**PRELIMINARY ISSUE**

Viewpoint - Stage F2  
Huntly, Bendigo

Drawing Title			
<b>Contents, Context Plan and Plant Schedule</b>			
Drawn	Approved	Date	North
AD	RH	03.12.2021	
Scale (A1)	Scale (A3)	Sheet	
NTS	NTS	1 of 6	
This drawing and design is protected by copyright © PLOT Landscape Architects Pty Ltd. www.plotla.com.au			
Drawing Number	Revision

**PLA488-L01 P2**

**Street Landscape Plan 1**

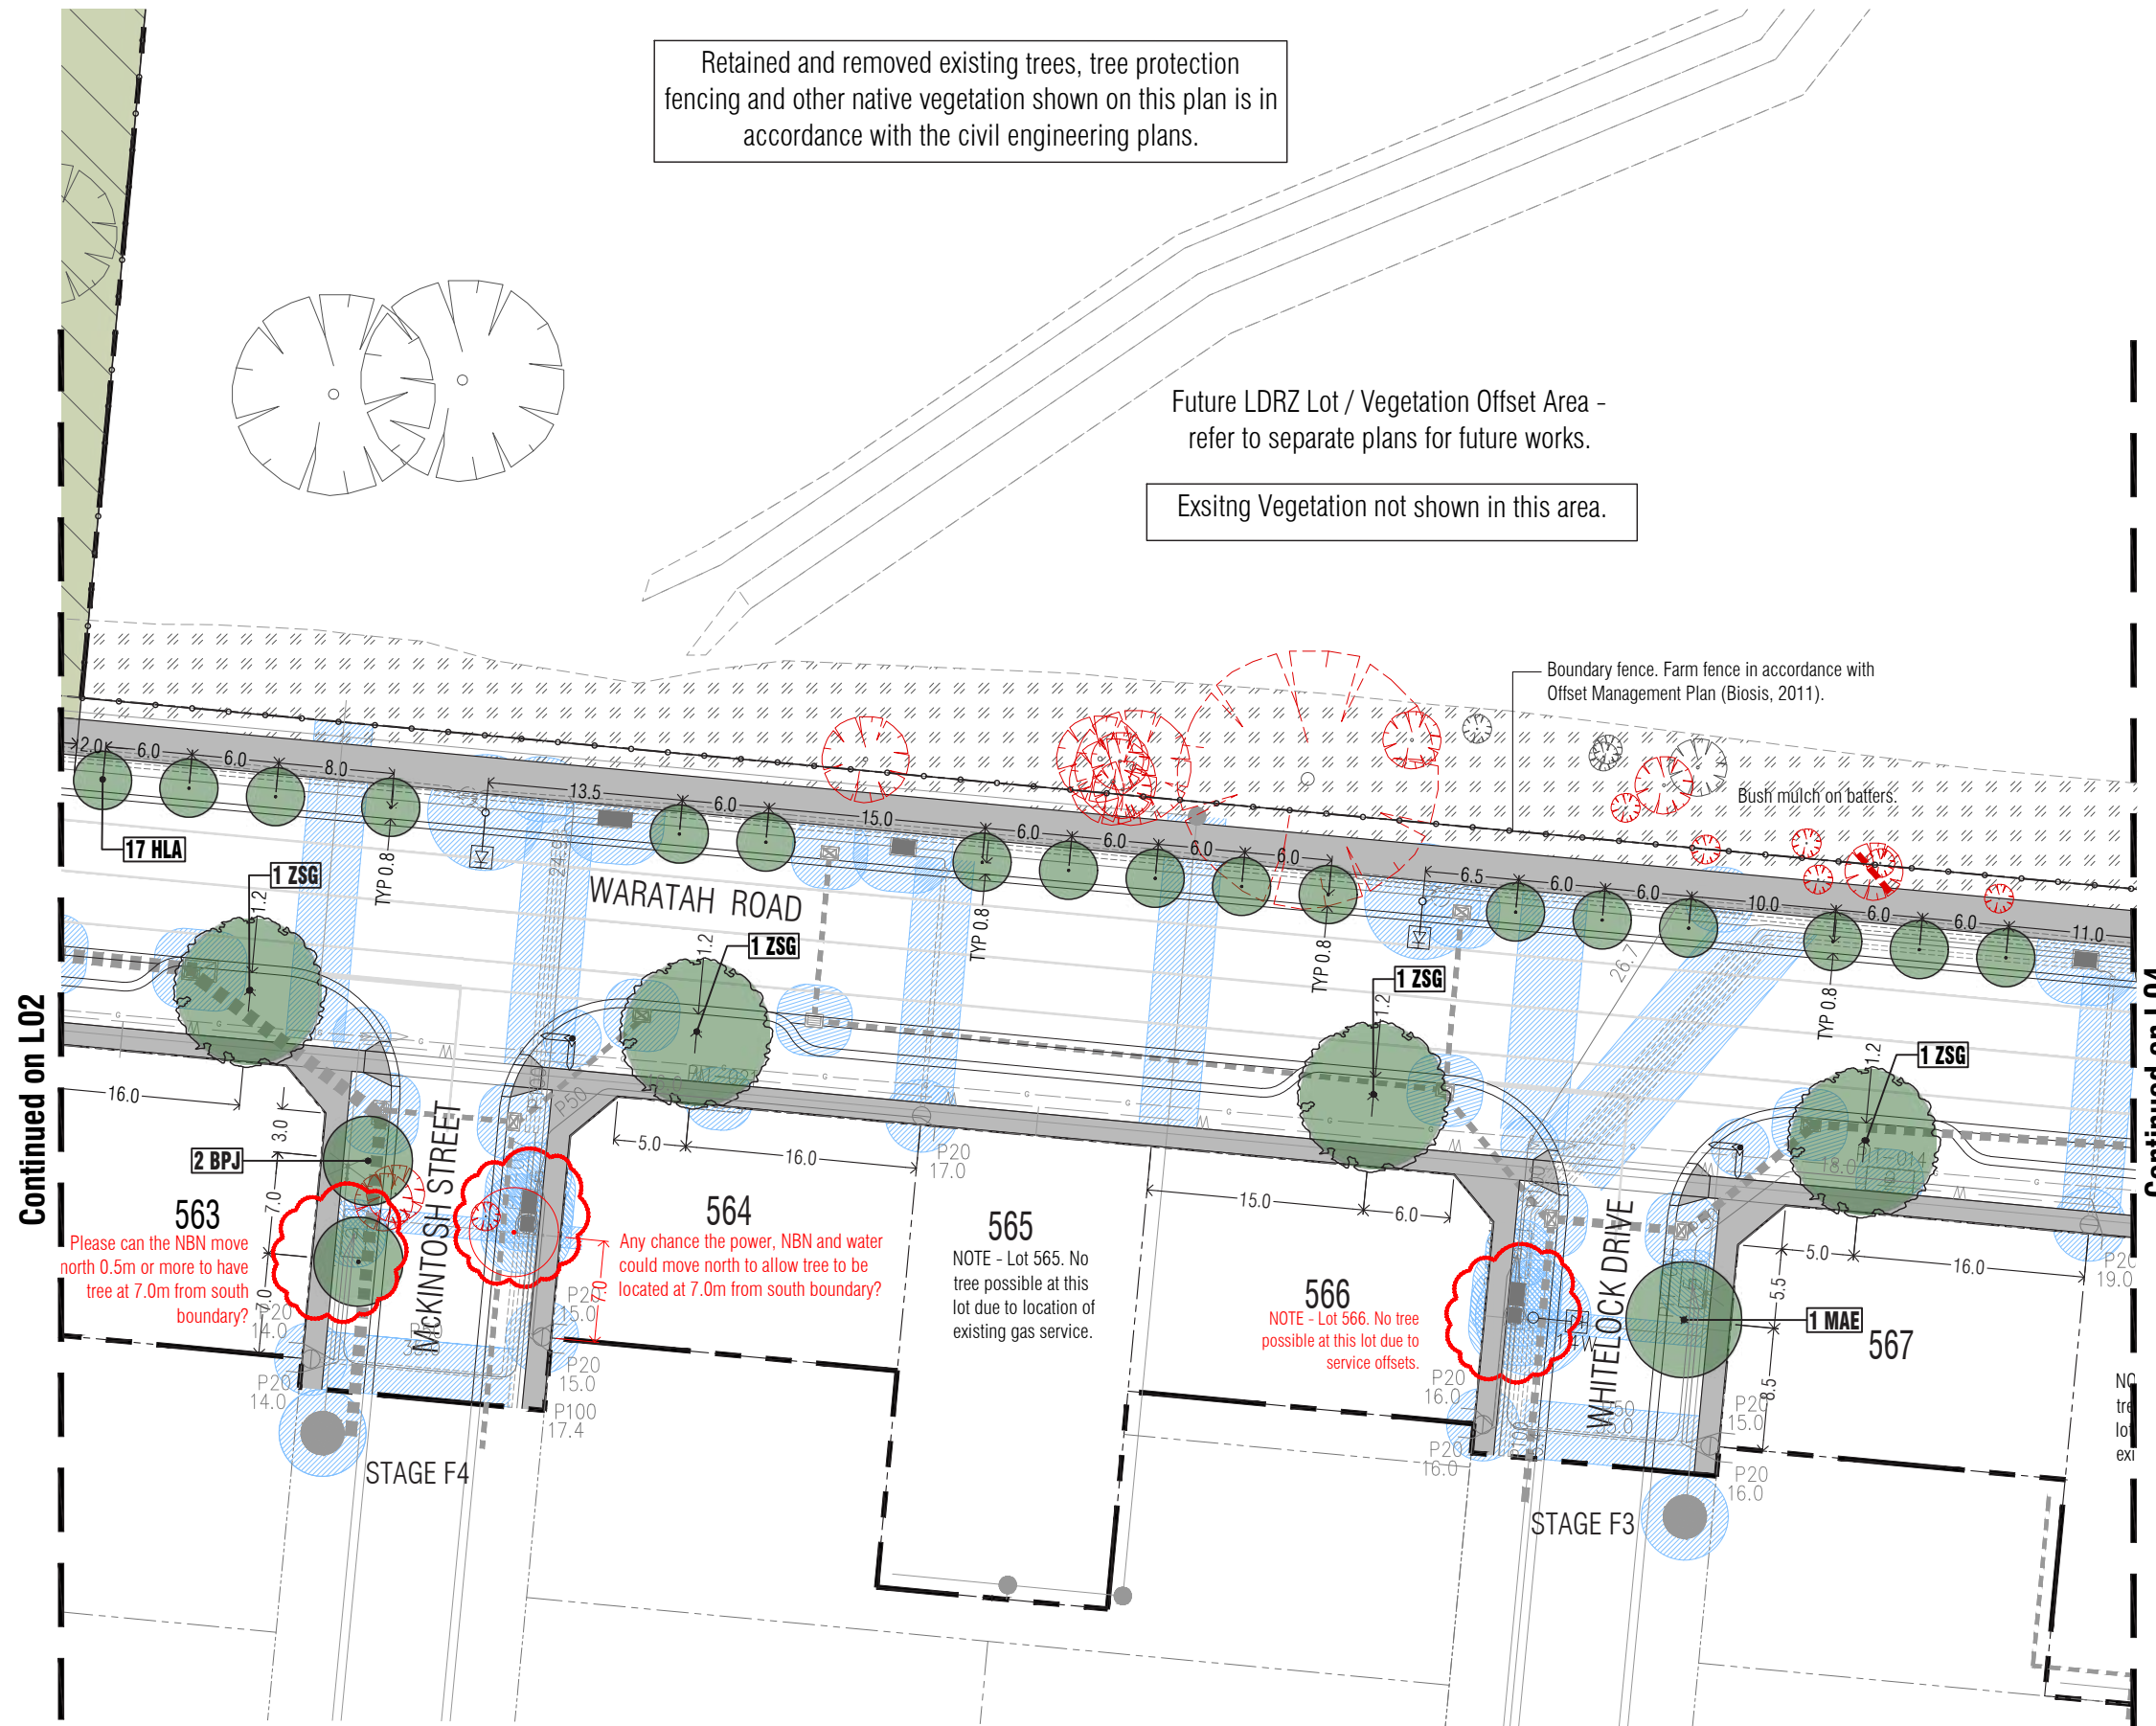
Is the path 1.0m from the boundary here, or directly adjacent to it. Base plan shows path not meeting here.

**Street Landscape Plan 5**

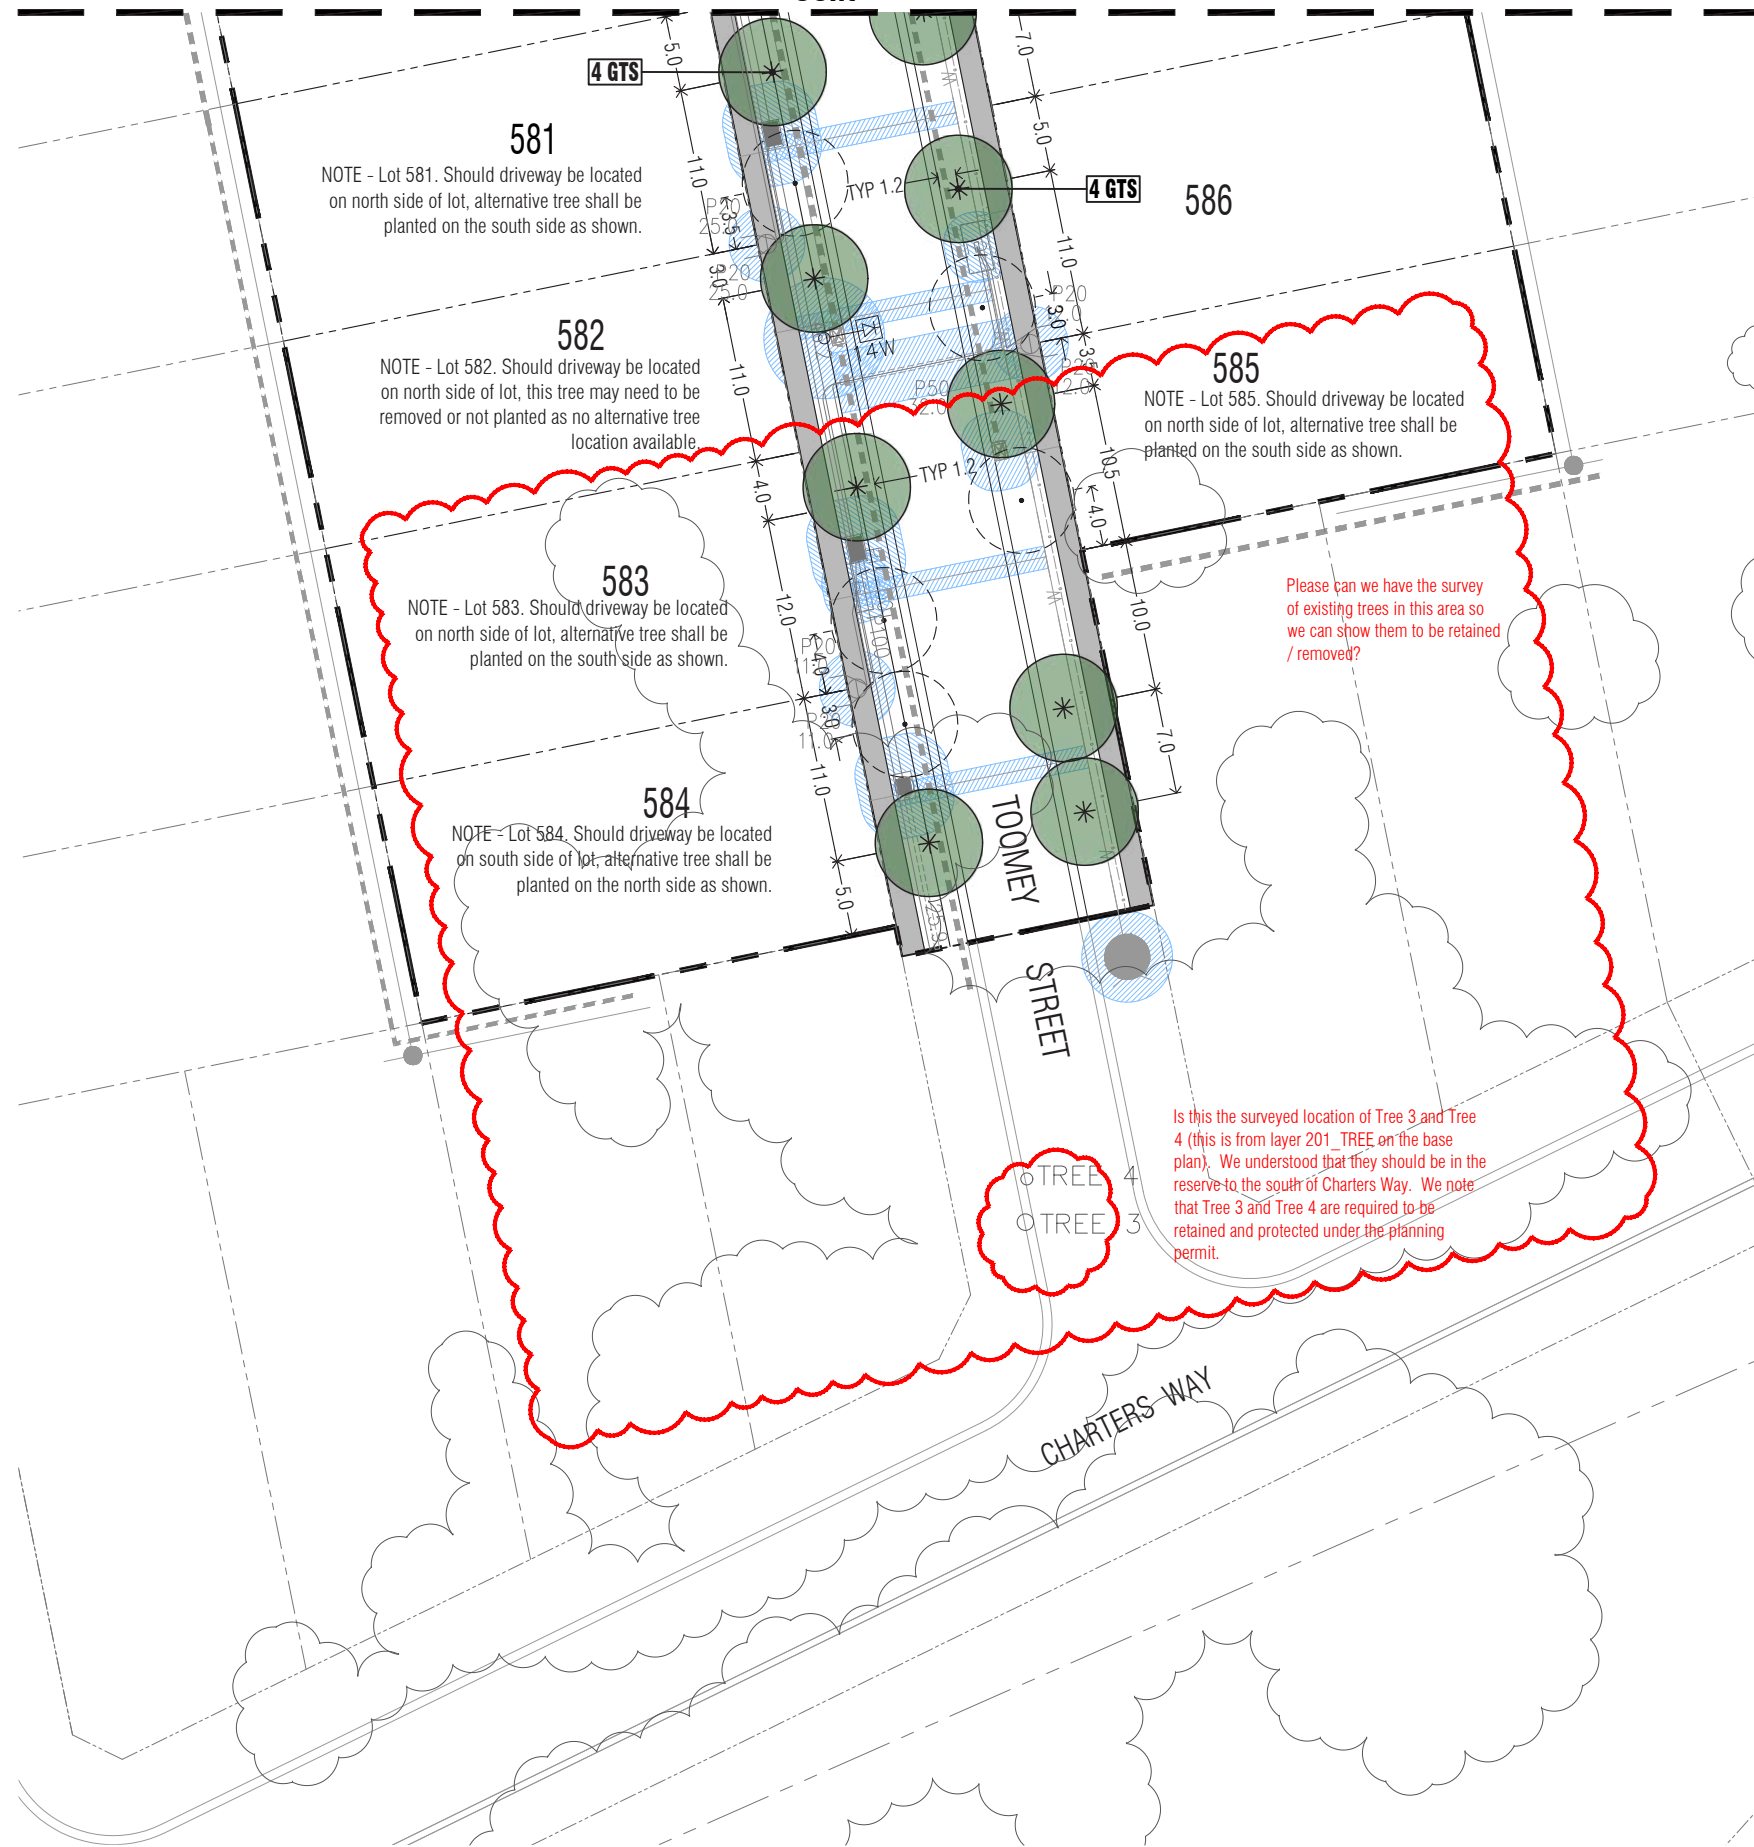
Please can we have the survey of existing trees in this area so we can show them to be retained / removed?

Is this the surveyed location of Tree 3 and Tree 4 (this is from layer 201\_TREE on the base plan). We understood that they should be in the reserve to the south of Charters Way. We note that Tree 3 and Tree 4 are required to be retained and protected under the planning permit.
